ATTACHMENT I To IPN-86-28
PROPOSED TECHNICAL SPECIFICATIONS

NEW YORK POWER AUTHORITY
INDIAN POINT 3 NUCLEAR POWER PLANT
DOCKET NO. 50-286

ATTACHMENT II to IPN-86-28
SAFETY EVALUATION

I. DESCRIPTION OF CHANGE

FIGURE 3.8-1

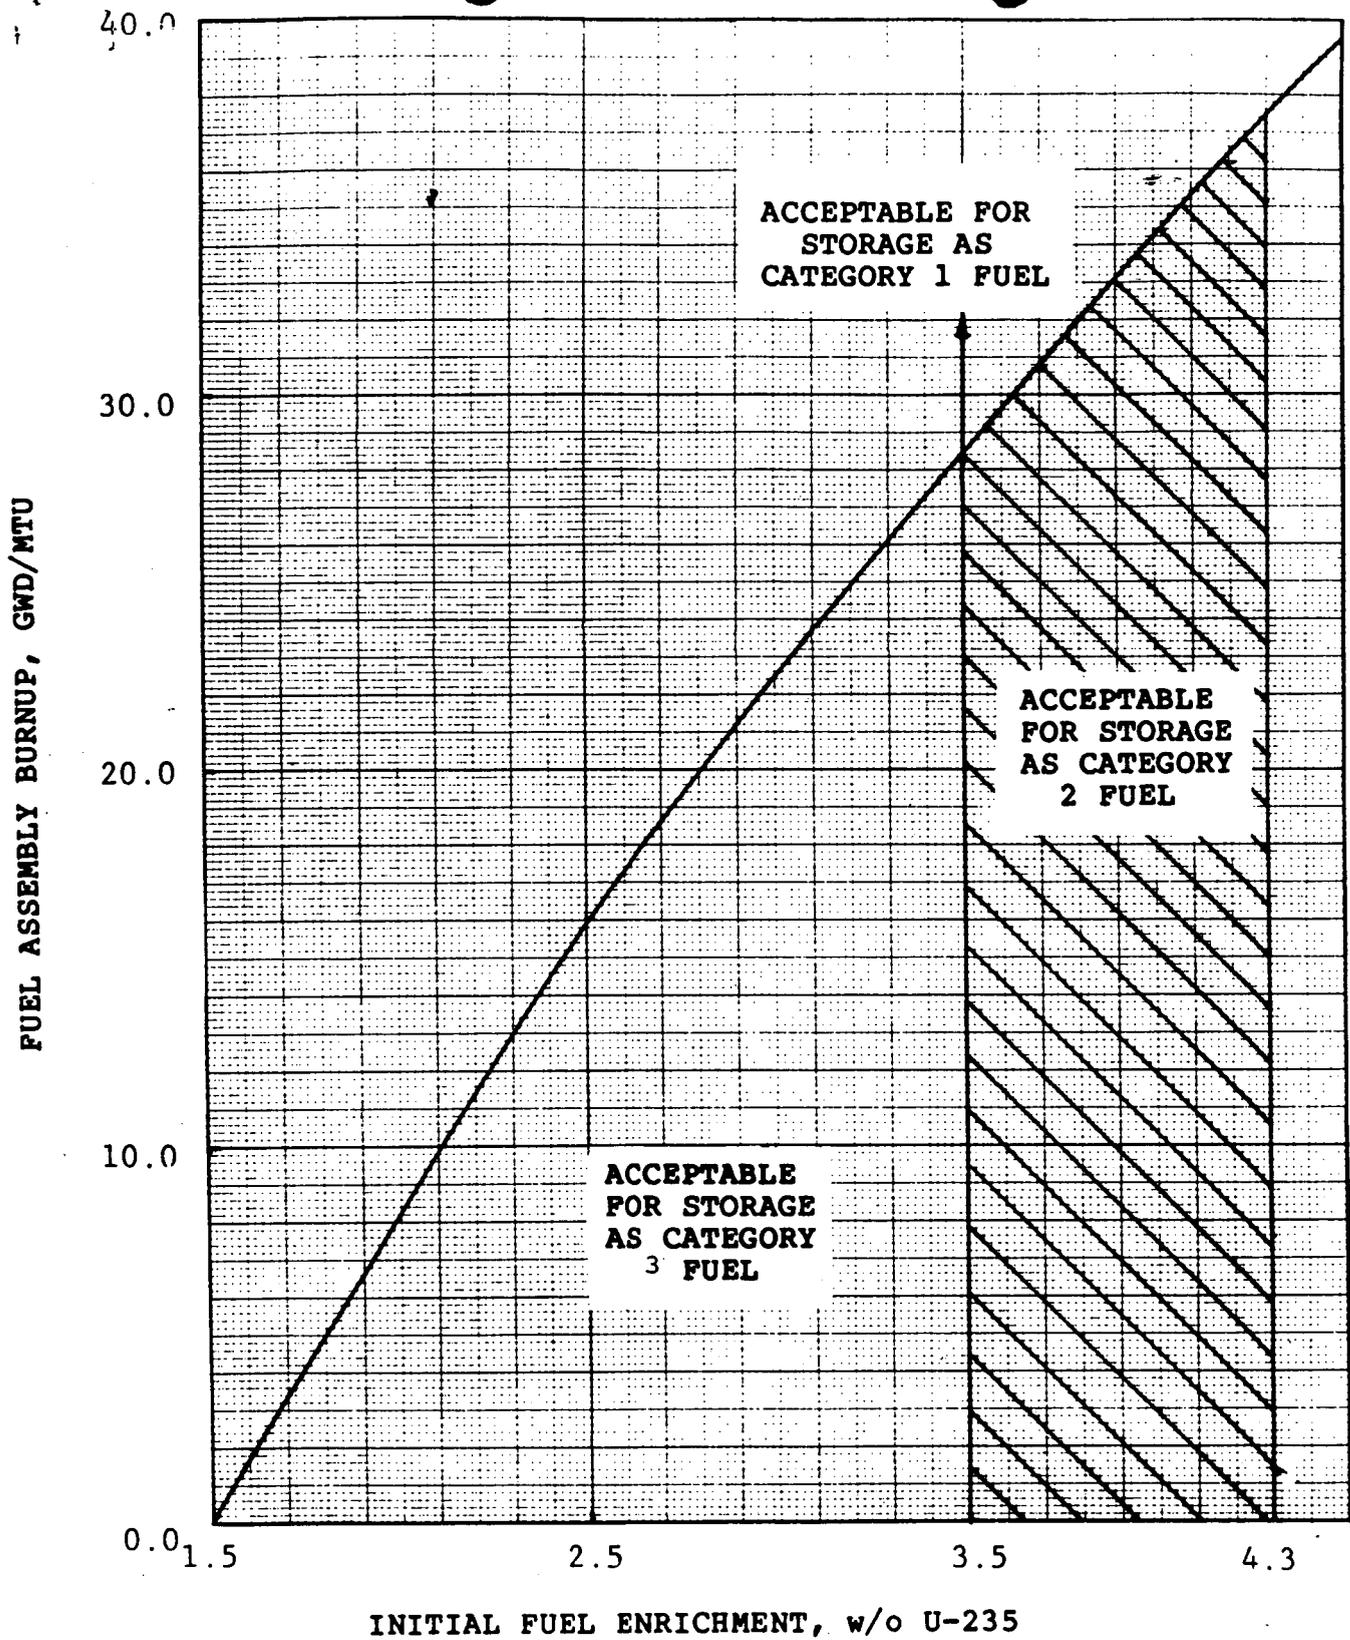
7. Fuel assemblies to be stored in the spent fuel pit can be categorized as either Category 1, 2 or 3 based on burnup and initial enrichment as specified in Figure 3.8-1. Category 2 fuel shall be loaded into the spent fuel pool storage locations in a checkerboard fashion with the intermediate storage locations containing Category 1 fuel, non-fuel materials or left empty. Unless restricted by the above, Category 1 or 3 fuel can be stored in any location in the spent fuel pool.

Fuel assemblies whose initial enrichment is greater than 3.5 w/o U-235 but less than or equal to 4.3 w/o can be stored in the spent fuel pool providing they are placed in a checkerboard array with fuel whose initial enrichment and burnup are sufficient to ensure that K_{eff} is less than 0.95 with no soluble boron present. This is ensured by categorizing the fuel whose initial enrichment is greater than 3.5 w/o U-235 but less than or equal to 4.3 w/o and whose burnup is below the curve of Figure 3.8-1 as Category 2. This fuel can be stored by checkerboarding with Category 1 fuel which is defined as fuel whose initial enrichment and burnup place it on or above and to the left of the curve in Figure 3.8-1. Category 3 fuel which is less than or equal 3.5 w/o U-235 and below the curve of Figure 3.8-1 cannot be used in the checkerboard with Category 2 fuel. Any Category 1 or 3 fuel can continue to be stored on a repeating x-y array with other non-Category 2 fuel. For the purpose of storing Category 2 fuel, non-fuel material or empty locations can be utilized in place of Category 1 fuel.

- CATEGORY 1 - AREA ALONG THE CURVE AND ABOVE
- CATEGORY 2 - AREA BELOW THE CURVE AND $3.5 < \epsilon \leq 4.3$ w/o U-235
- CATEGORY 3 - AREA BELOW THE CURVE AND $\epsilon \leq 3.5$ w/o U-235

FIGURE 4-1

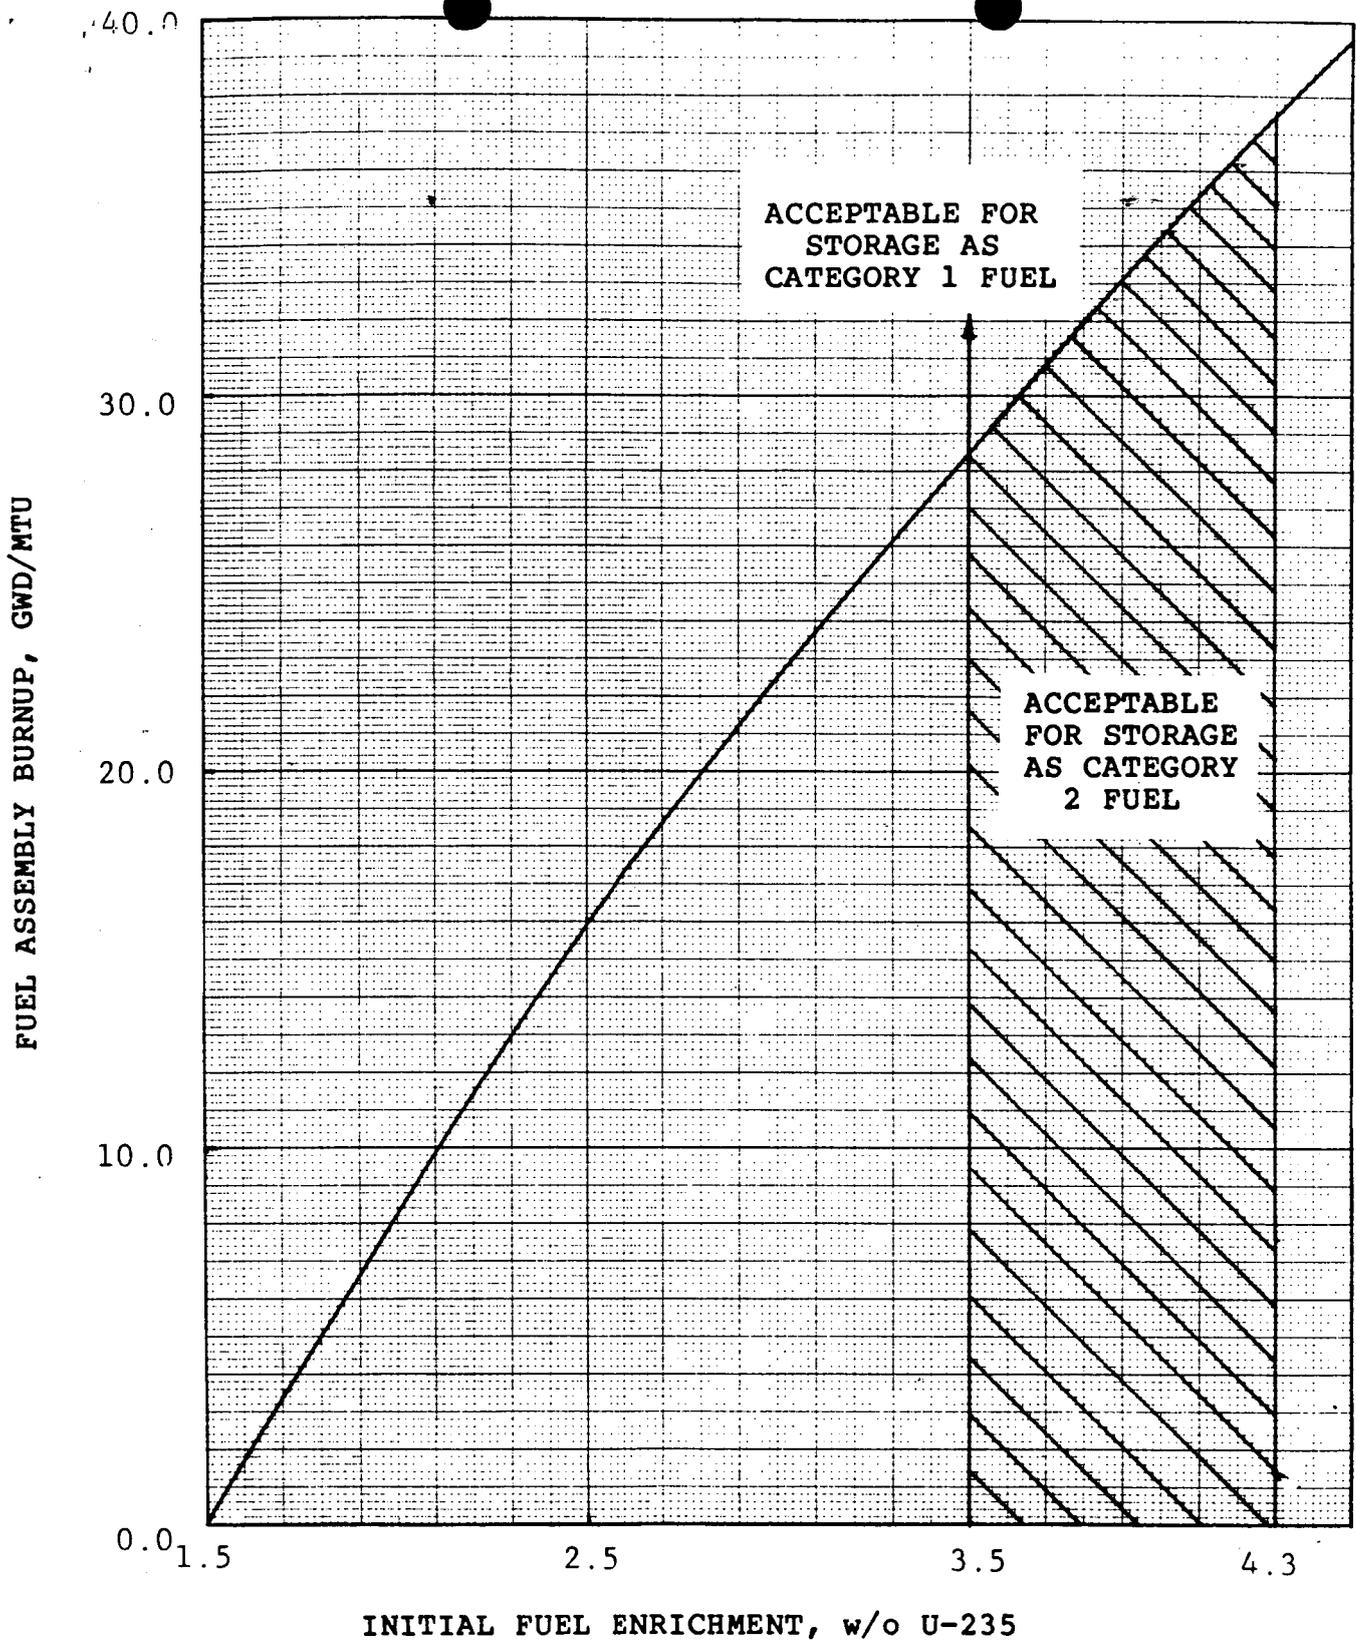
In order to increase the enrichment of fuel which can be stored in the existing spent fuel storage racks, two categories of fuel are defined, category 1 and category 2. Category 1 fuel is defined as having combinations of initial fuel enrichment and exposures above and to the left of the curve in Figure 4-1. Category 2 fuel is defined as having initial fuel enrichment between 3.5 w/o and 4.3 w/o U-235 and corresponding exposures below and to the right of the curve in Figure 4-1 as represented by the cross-hatched portion. In order to store category 2 fuel in the spent fuel storage racks, category 1 fuel must be loaded into the racks in a checkerboard fashion with the intermediate storage cells reserved for category 2 fuel. In this manner, the reactivity of the assembly array is limited by requiring that the reactivity of the cell contents directly adjacent to category 2 assemblies be less than or equal to the

The supplemental nuclear analyses described in this report are the basis for the constant rack reactivity curve shown in Figure 4-1.

Table 5-2 contains the exposure level for fuel assemblies with initial enrichments from 1.5 to 4.3 w/o U-235 which provides constant fuel/rack reactivity. These analyses are the basis for the curve shown in Figure 4-1 which defines the category 1 and 2 fuel types.

CATEGORY 1 - AREA ALONG THE CURVE AND ABOVE

CATEGORY 2 - AREA BELOW THE CURVE AND $3.5 < e \leq 4.3$ w/o U-235
